CLAREMONT BUSINESS PARK 2 FILING NO. 1

GRADING AND EROSION CONTROL PLAN

GRADING & EROSION CONTROL PLAN
CLAREMONT BUSINESS PARK 2 FIL. NO. 1
JOB NO. 44-037
DATE PREPARED: APRIL 28, 2020
DATE REVISED: AUGUST 5, 2020

EL PASO COUNTY FILE NO. SF 20-014

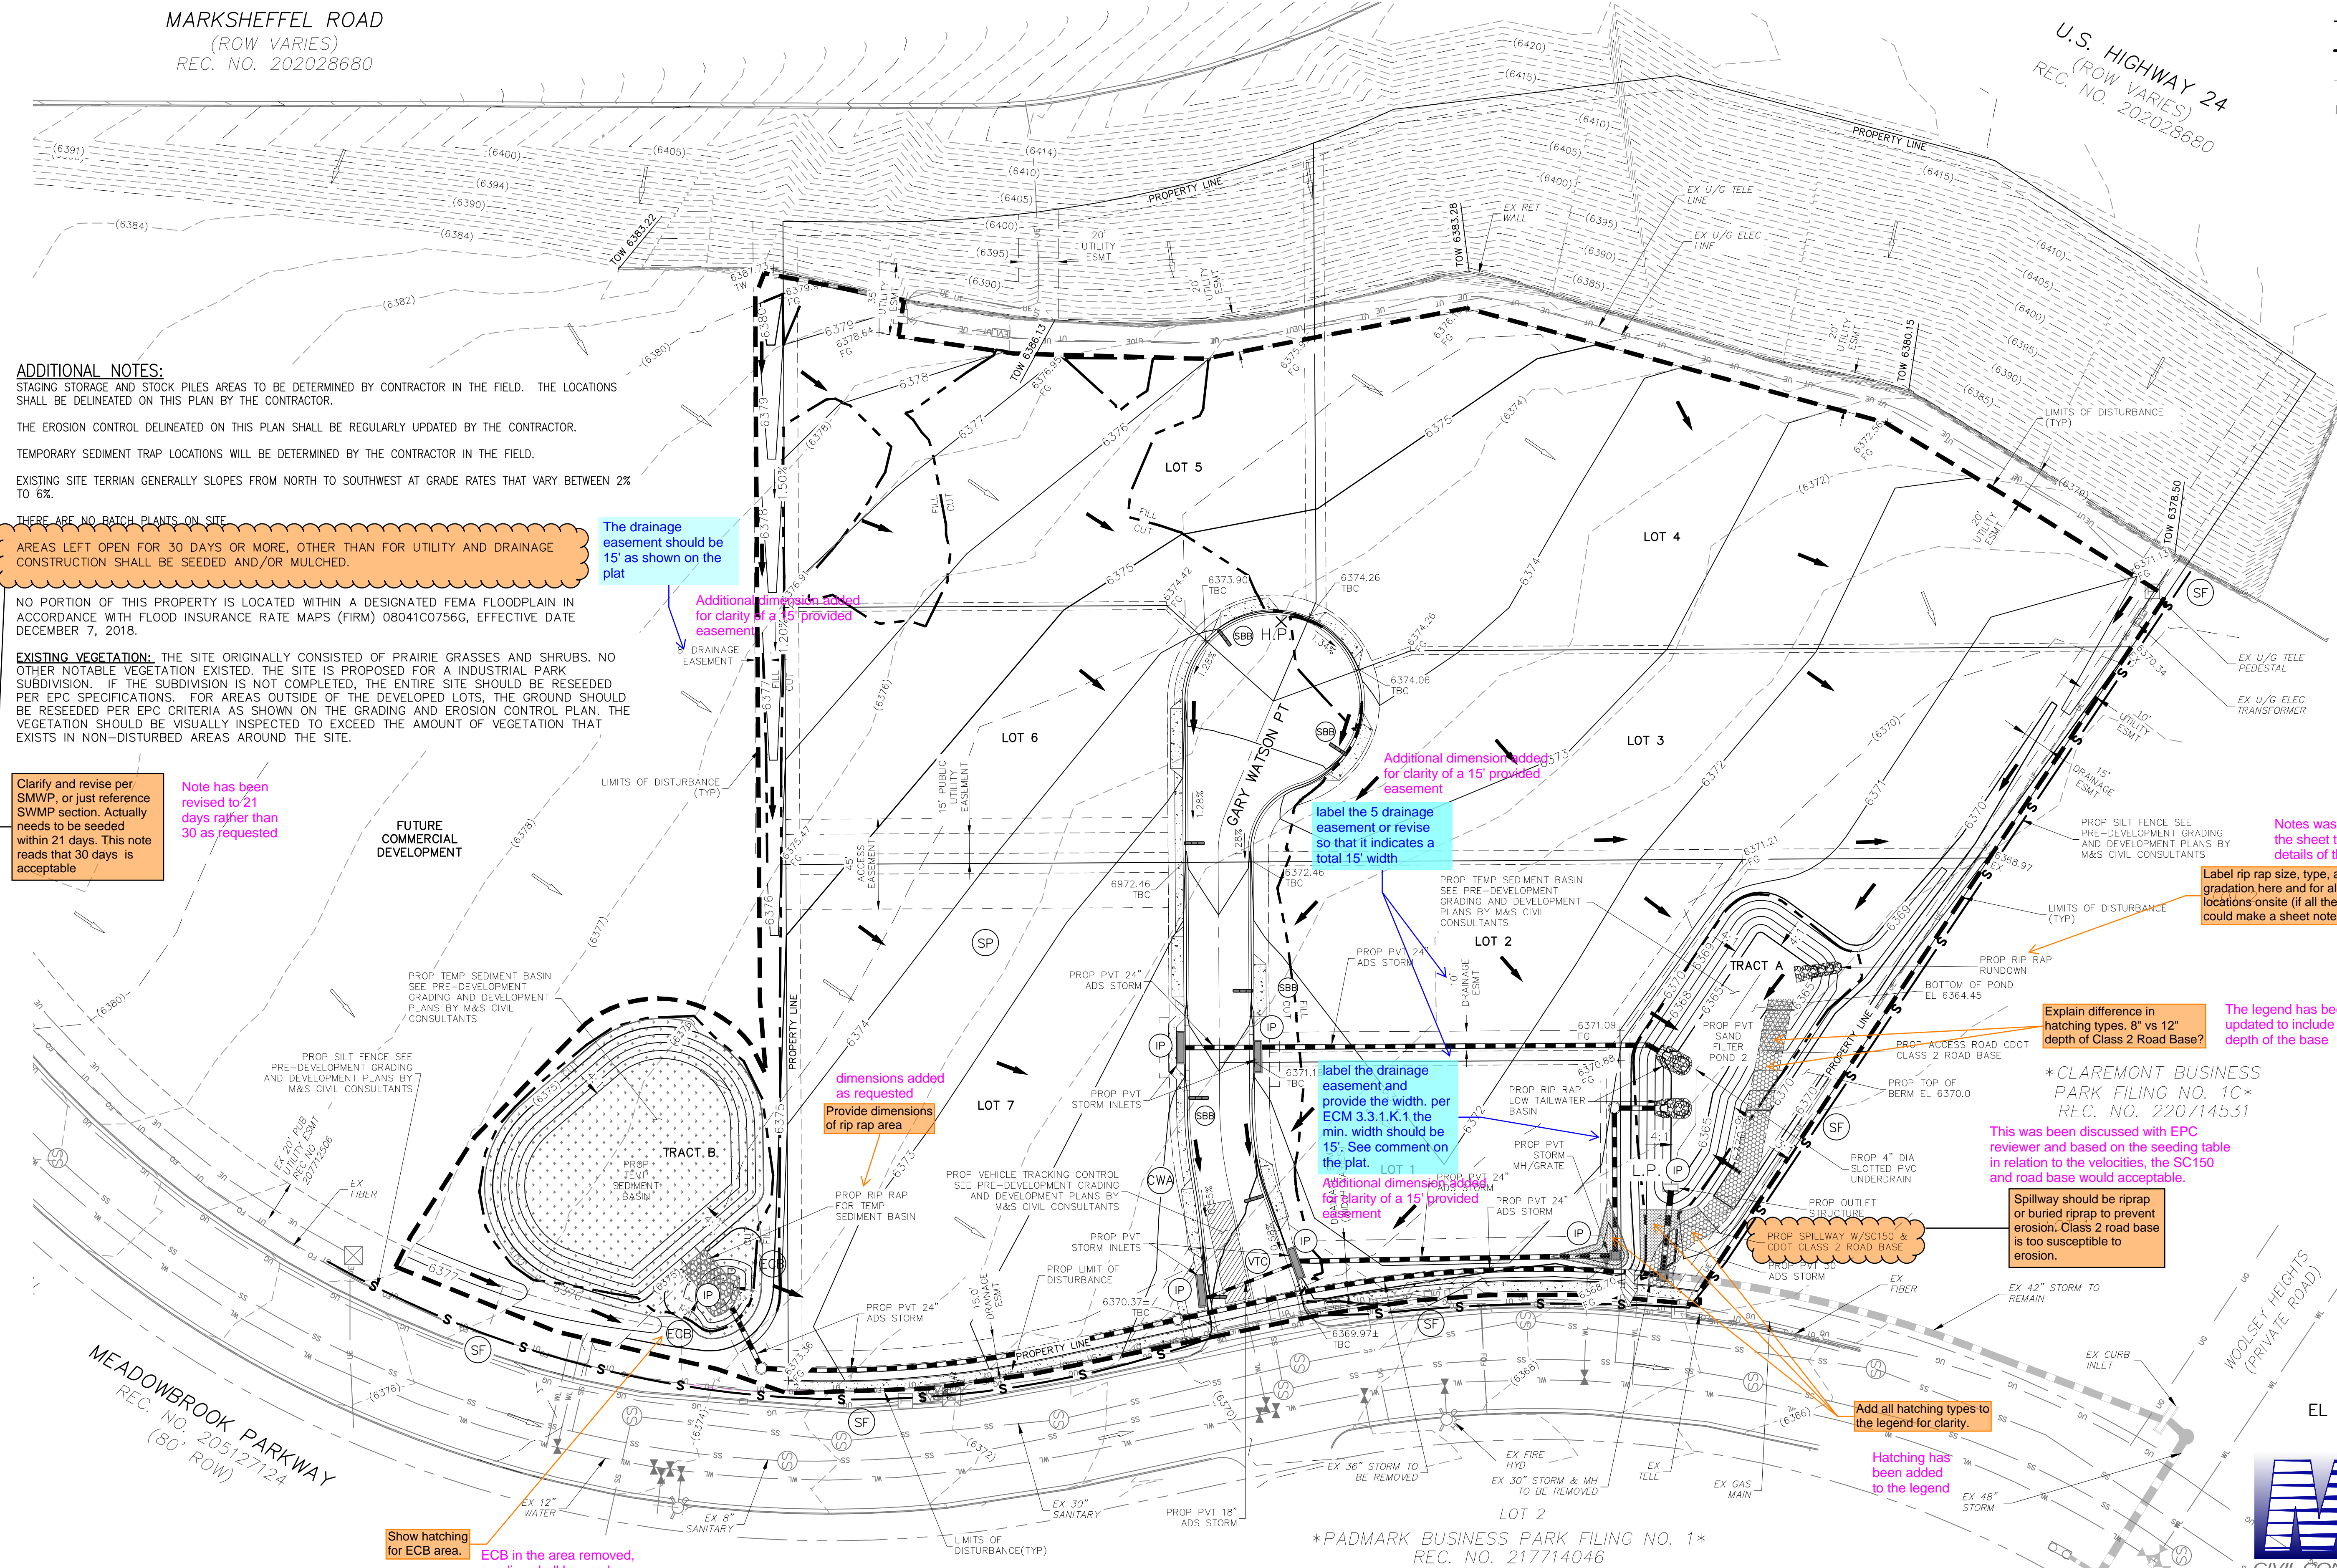
SWMP Checklist Item 17a - Should read "Limits of Disturbance / Construction" (if they are the same, otherwise make a separate line type for Limits of Construction).

Clarify and revise per SMWP, or just reference SWMP section. Actually needs to be seeded within 21 days. This note reads that 30 days is acceptable

The drainage easement should be 15' as shown on the plat

label the 5 drainage easement or revise so that it indicates a total 15' width

label the drainage easement and provide the width, per ECM 3.3.1.K.1 the min. width should be 15'. See comment on the plat.

Explain difference in hatching types. 8" vs 12" depth of Class 2 Road Base?

Spillway should be riprap or buried riprap to prevent erosion. Class 2 road base is too susceptible to erosion.

Add all hatching types to the legend for clarity.

Label rip rap size, type, and gradation here and for all rip rap locations onsite (if all the same, could make a sheet note)

Add details for the following BMP's using the provided ones from the DCM, MHFD, or equivalent.

Note has been revised to 21 days rather than 30 as requested

Additional dimension added for clarity of a 15' provided easement

Additional dimension added for clarity of a 15' provided easement

dimensions added as requested
Provide dimensions of rip rap area

Additional dimension added for clarity of a 15' provided easement

The legend has been updated to include the depth of the base

This was been discussed with EPC reviewer and based on the seeding table in relation to the velocities, the SC150 and road base would be acceptable.

Hatching has been added to the legend

a sheet has been added to included the additional details
